## REQUEST

Proposed Zoning: MUDD-O (mixed-use development district, optional) and MUDD-O SPA (mixed-use development district, optional, site plan amendment) with 5-years vested rights.

Approximately 45.67 acres located on the west side of South Tryon Street, north side of Clanton Road, and east side of Interstate 77.

## STAFF RECOMMENDATION

### • Proposed Request Details

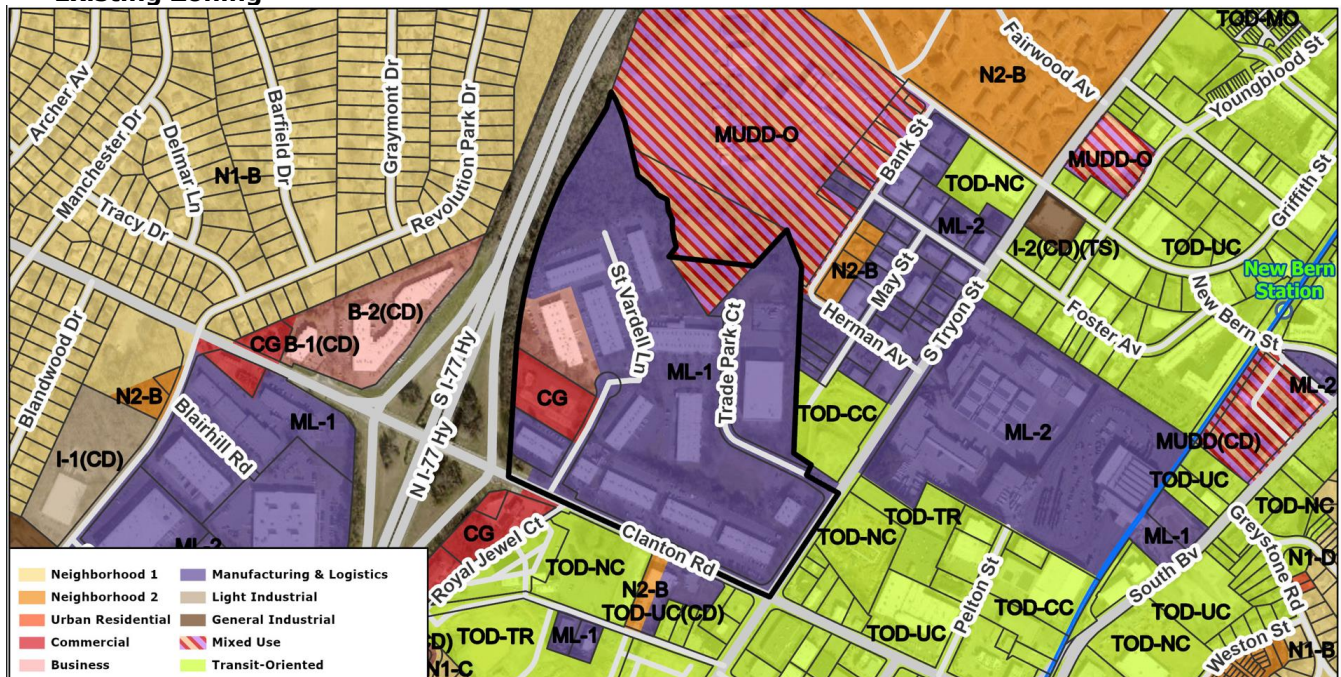
1. Update the TIS with conditional notes regarding mitigation at Clanton Road/I-77 interchange.
2. Include a commitment to construct an ADA compliant bus stop along Clanton Road.

3. Increase the specified minimum transparency for upper floors from 15% to 25%.
4. Provide detail on which development area(s) the gas station may be located in and provide a limitation on the number of pumps that would be in the gas station use. Consider adding a commitment to EV charging stations.

5. Revise the design standards for gas stations to commit to a minimum ground floor height for gas stations and orientation of canopies to the rear or side of the street.

6. Revise the minimum ground floor height for multi-family uses to 16 feet rather than all residential uses having a minimum ground floor height of 10 feet.

7. Revise the design standard notes for drive-throughs so that no drive aisle may be located between the building façade and the street, menu boards may not be visible from the street, and note that seat walls that meet screening requirements will be provided to enhance the pedestrian environment.

8. Commit to a maximum number of principal uses may have an accessory drive-through and provide further limitations on which part of the site may have an accessory drive-through, allowing this use on approximately 1/3 of the site is too broad. Staff would support modifying the note to only allow accessory drive-throughs in Development Area A2.

9. In note 6 of the optional provisions add the word "reasonable" after the word "allow" in the first sentence.
10. In note 5 of the General Transportation and Streetscape notes add "as approved by CDOT and NCDOT" at the end of the note.
11. Fill in the referenced date of the approved TIS throughout the conditional notes.

12. Clarify note i in the conversion rates notes to detail the maximum number of hotel rooms or residential units that may be created in the conversion of 500 square feet of commercial uses to one hotel room or residential unit.
